00 ANN ARBOR HISTORIC DISTRICT COMMISSION**Staff Report****ADDRESS:** 549 S First Street, Application Number HDC23-0187**DISTRICT:** Old West Side Historic District**REPORT DATE:** November 9, 2023**REPORT PREPARED BY:** Jill Thacher, Historic Preservation Coordinator**REVIEW COMMITTEE DATE:** November 6, 2023**OWNER****APPLICANT****Name:** Nick CollinsKasey Vliet
In Parallel Architects
4621 Freedom Drive
Ann Arbor, MI 48108**Address:****Phone:** (646) 246-8246

APPLICATION: The applicant seeks HDC approval to rebuild both the main roof and rear addition roof, alter a non-original window, remove the chimney, remove an attic vent in the front gable, remove the stone foundation and porch walls and rebuild the stone portion above grade, replace wood basement windows with aluminum-clad wood hopper windows, convert an existing basement window into an egress window, install a mini-split, and install a wood fence that is 6'-8' tall.

PROPOSED WALL SECTION

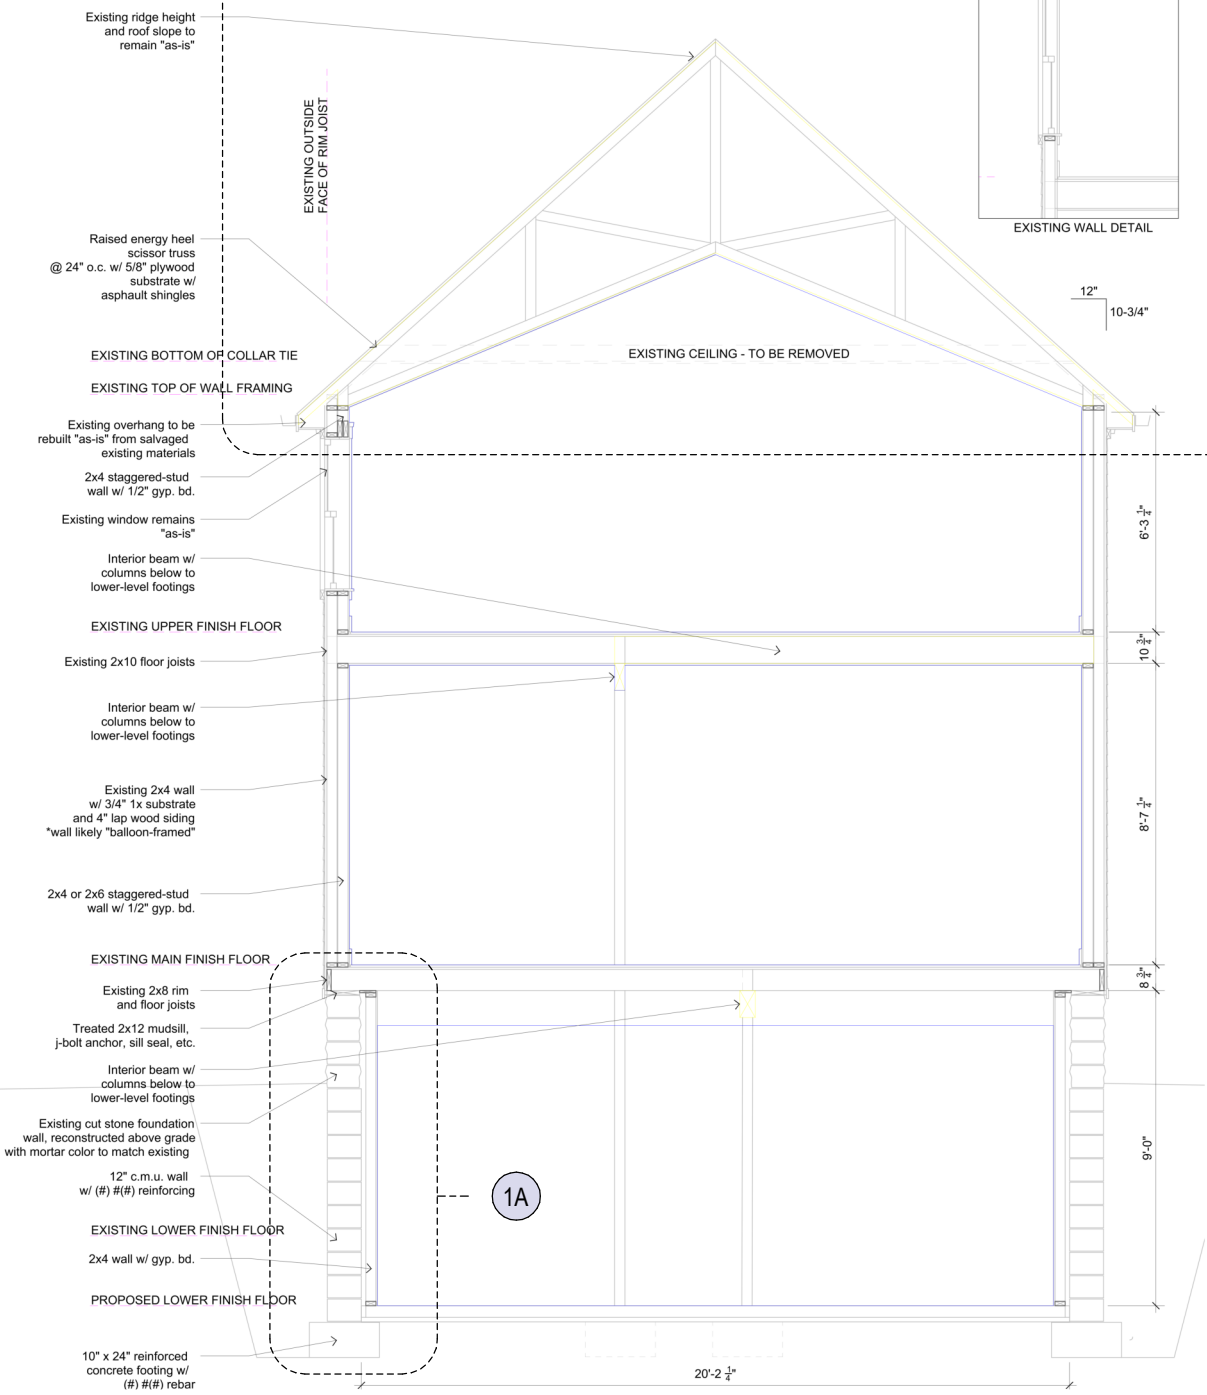
6. The basement is failing and the applicant proposes to take down the cut stone, rubble and concrete basement walls, rebuild them with concrete masonry units, and reassemble the cut stone above ground level. Similarly, the stone front porch is proposed to be disassembled and reassembled with new mortar. Staff has concerns, especially about the cut stone foundation and its reassembly and whether the new appearance will match. Staff strongly recommends that the mason who will be working on the project attends the HDC meeting to explain the rationale behind this part of the project and how the walls will be put back together in a way that matches the historic appearance.

The scope of renovation work includes increasing lower level ceiling height by digging down and lowering foundation and basement floor slab. Existing foundation includes a combination of cut stone and cobblestone, which has been underpinned with concrete below grade at multiple locations. The existing foundation and porch are compromised and require repair. Considerable water damage can be seen at foundation interior. The existing foundation wall encroaches significantly into usable lower level space. Our consultation with several local masons has resulted in a consensus that additional tuckpointing will be insufficient in maintaining existing foundation and that further underpinning the existing already underpinned areas would be structurally unstable and also encroach even further into the usable lower level space, further reducing its function.

We propose to reconstruct the existing house and porch foundation walls using reinforced concrete block below grade and the existing stones with mortar to match the existing color above grade. This would provide a structurally stable and waterproofed foundation wall, while giving back usable space to the lower level function and enabling a higher ceiling height. This higher ceiling height is desired for general function and also for the installation of acoustical panels needed for a semi-professional recording and music practice space.

PROPOSED EGRESS WINDOW
ELEVATION

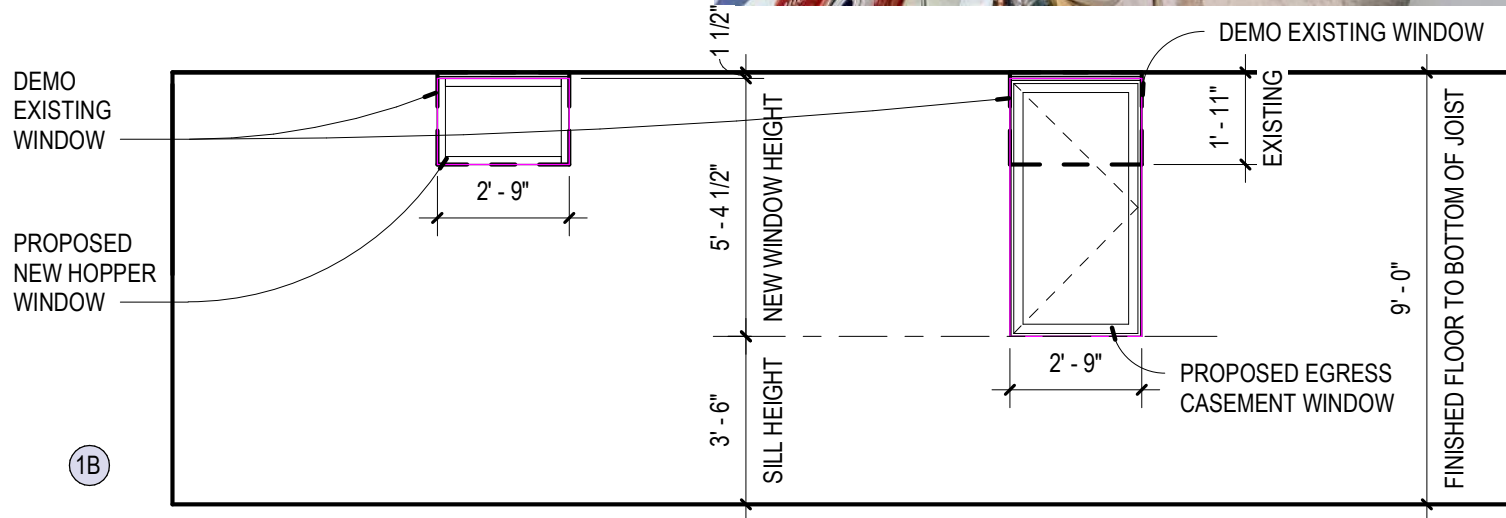
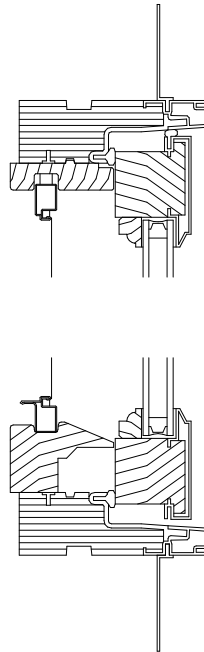
4. The basement windows are currently 2'9" x 1'11". The egress window is proposed on the south side of the house and would lower the sill to increase the height of the window to 5'5". An aluminum-clad wood casement window is proposed, with an aluminum well cover. The location of the window is not ideal since it is close to the front of the house, though it is preferable to cutting a new opening where none now exists.

We propose to convert existing southwest window to an egress window by extending the opening downward and retaining the existing opening width. The existing operable unit will be replaced by an operable aluminum-clad wood casement window. This location is best-conforming to egress code, and its position on the south elevation will increase natural lighting in the basement.

2 - MAIN LEVEL REAR WINDOW

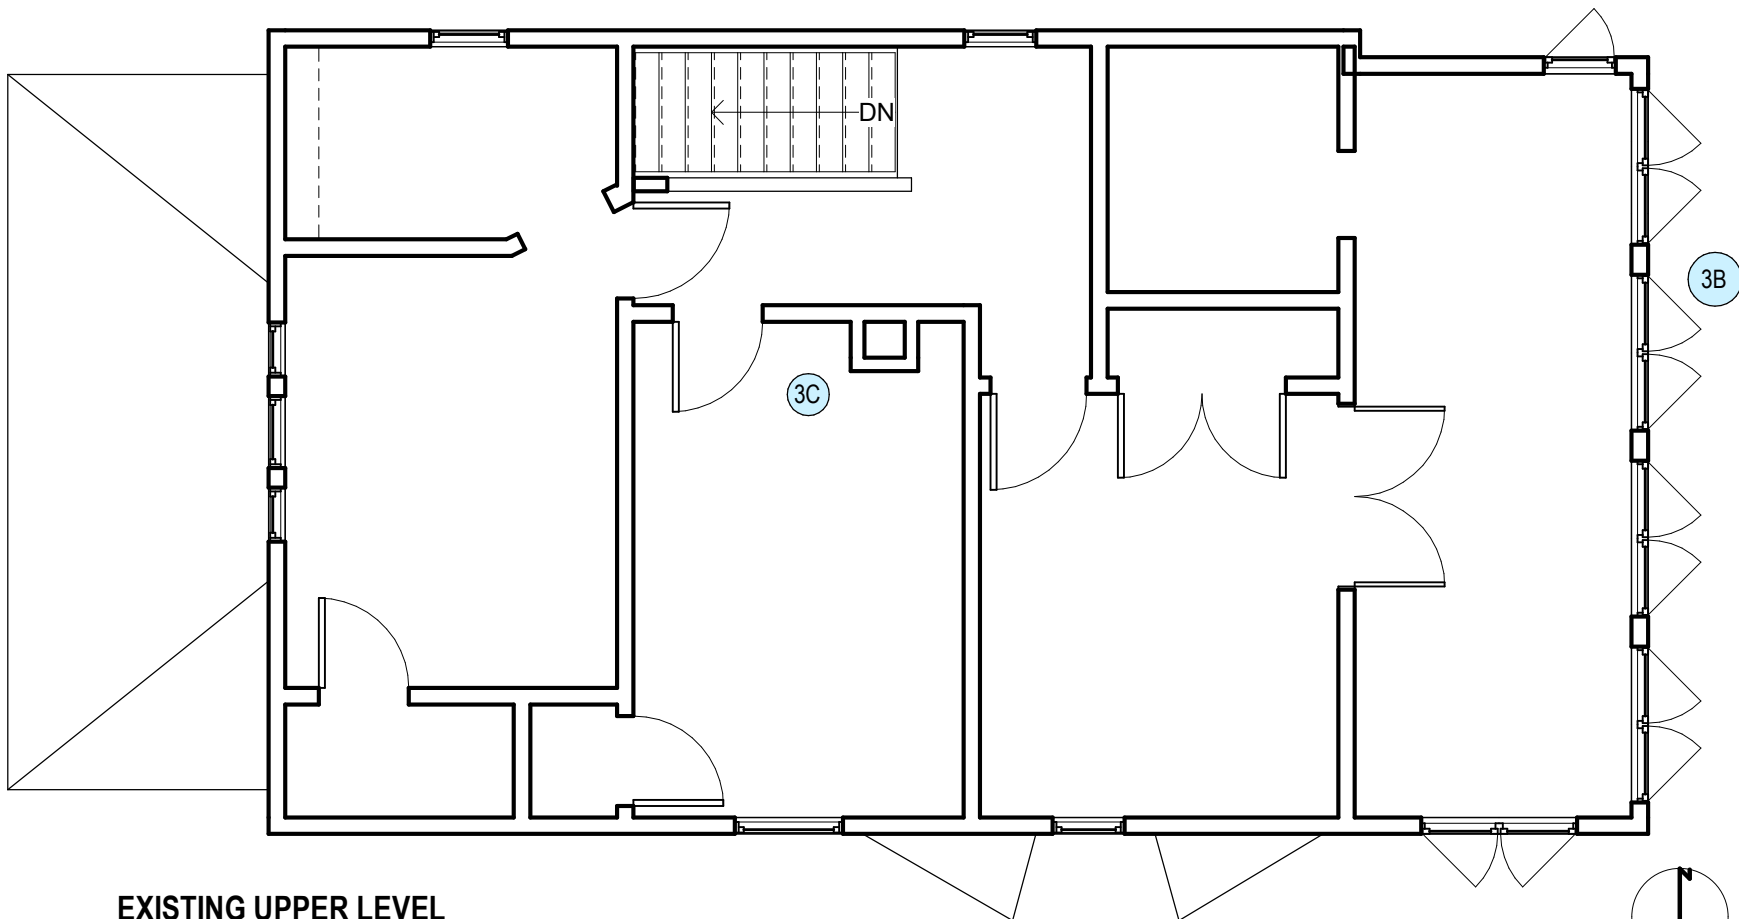
5. A large modern picture window is located on the rear elevation. It is proposed to be shortened in height to allow kitchen cabinets below. The exterior would be trimmed with boral and flush with the wall instead of boxed out, and siding would be infilled below the windows as needed. Since the window is disproportionately large and not original, this work is appropriate.

We propose to replace existing fixed window with smaller aluminum-clad picture window, and eliminate non-historic box-bay, flushing out exterior rear wall. This window would be trimmed with new borat, painted to match existing typical aluminum wrapped wood trim. Wood siding would be patched and painted to match existing, as required.

3B - UPPER LEVEL REAR WING, WINDOWS

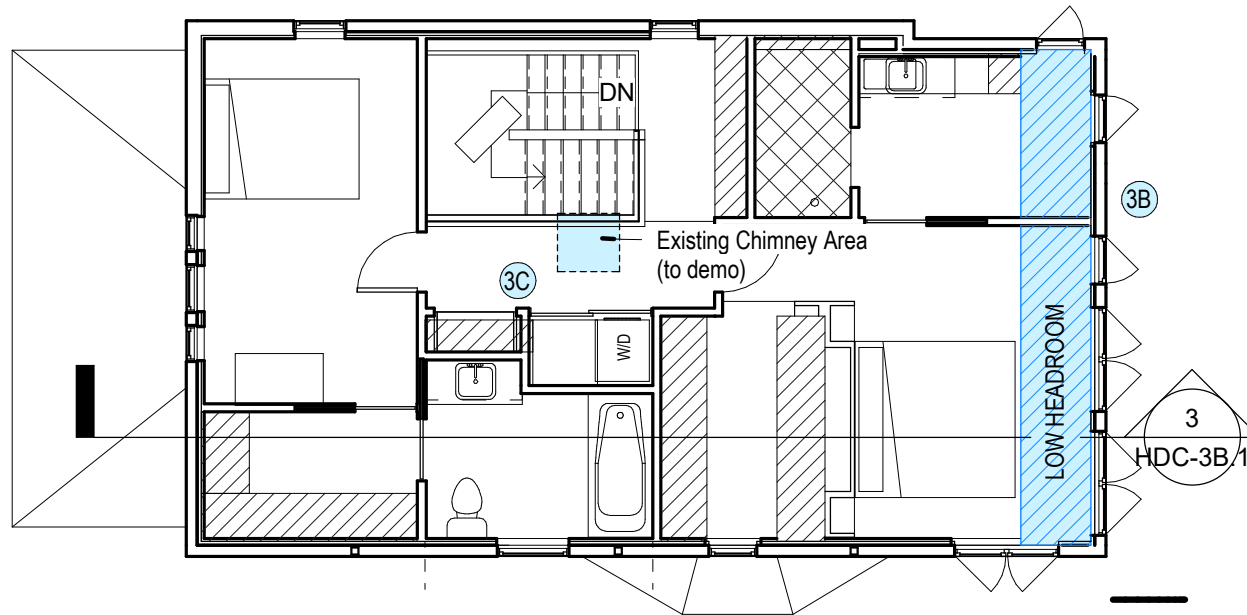
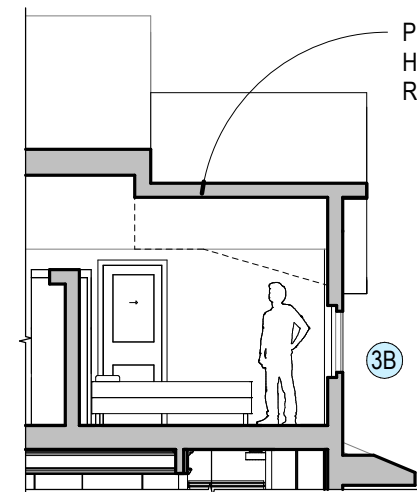
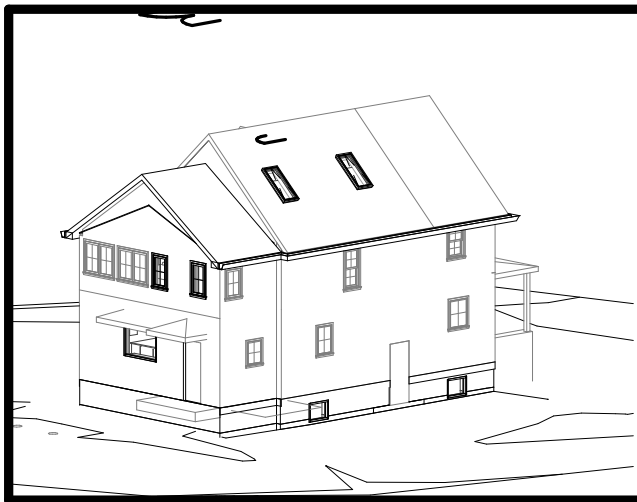
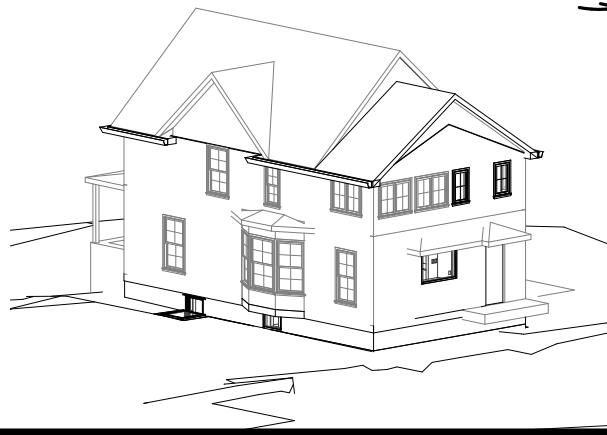
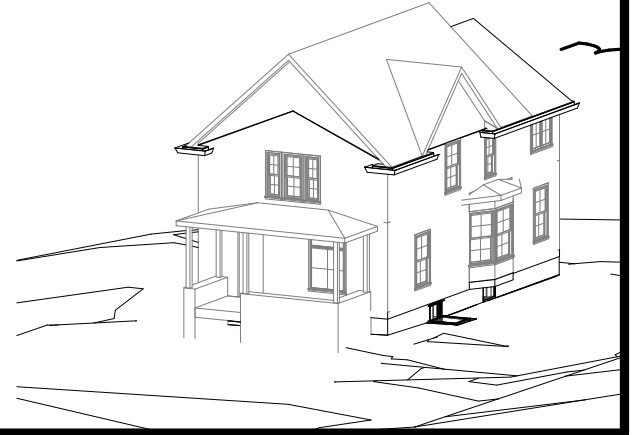
2. The roof on the addition would be converted from a hip to rear-facing gable. Two of the eleven windows on this modern upper floor addition would be removed. While the roof is slightly asymmetrical since the addition does not run the entire width of the back of the house, it is compatible as proposed. A rear attic window would be lost to the new roof. The window appears to be modern.

We propose to replace existing hip roof structure with new gabled truss framing, mitigating low-headroom space on the upper level. This gable is to sit below the primary roof, with shallower pitch to maximize historic primary roof trim detail. The new roof line requires the demolition of existing attic window. New aluminum clad wood windows at the upper level will replace non-historic and energy inefficient sleeping porch windows. Wood trim, siding, and roof material are to match existing. New windows are to receive new boral trim, painted to match existing trim.

SITE PLAN

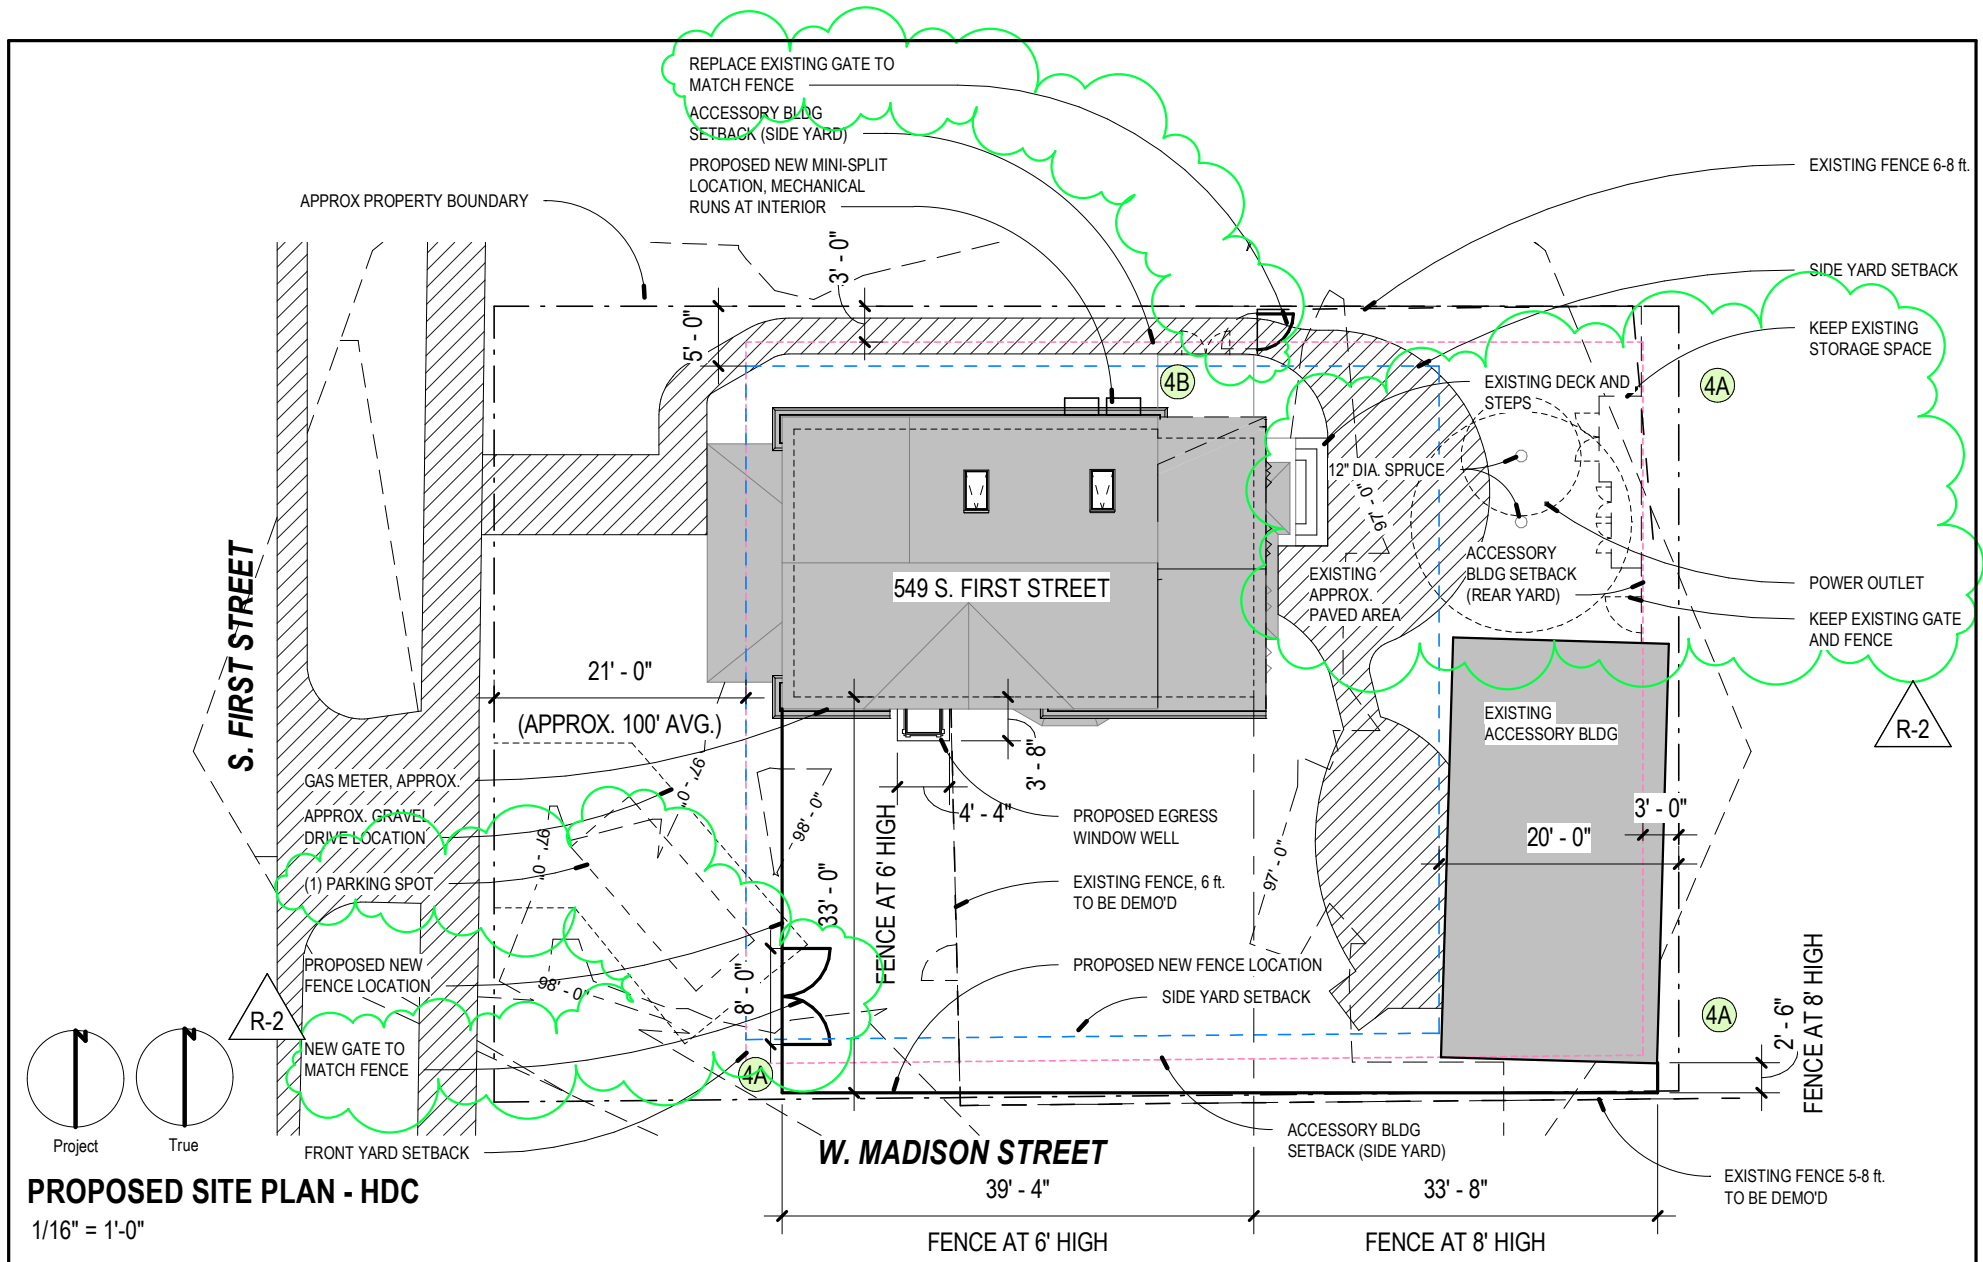
7. The current fence is wood and 6' or 8' tall. It is proposed to be replaced with a new, similar wood fence extends flush from the front of the house and follows parts of the south, east, and north property lines. A portion of the fence is currently 8', and the parts of the new fence behind the house are proposed to be 8'. This height requires HDC approval, not staff.

8. Two mini-split units are proposed on the north side of the house near the rear. These would replace an existing AC condenser. The line sets would run on the interior of the house.

We propose to replace existing fence, as illustrated, to conform to property boundaries, to obscure new egress well from view, and to expand the usable yard space for owner.

New fence will be designed to coordinate / match existing: Painted alternating wood board at 6' height in the side yards, retaining 8' height in rear yard

We propose to place new mini split on the north wall of the house, toward the rear (east) end. This is the location of the existing conditioning unit, and is adjacent to the mechanical space on the lower level. New mechanical linesets will be run on the interior of north wall and not be exposed on the exterior.
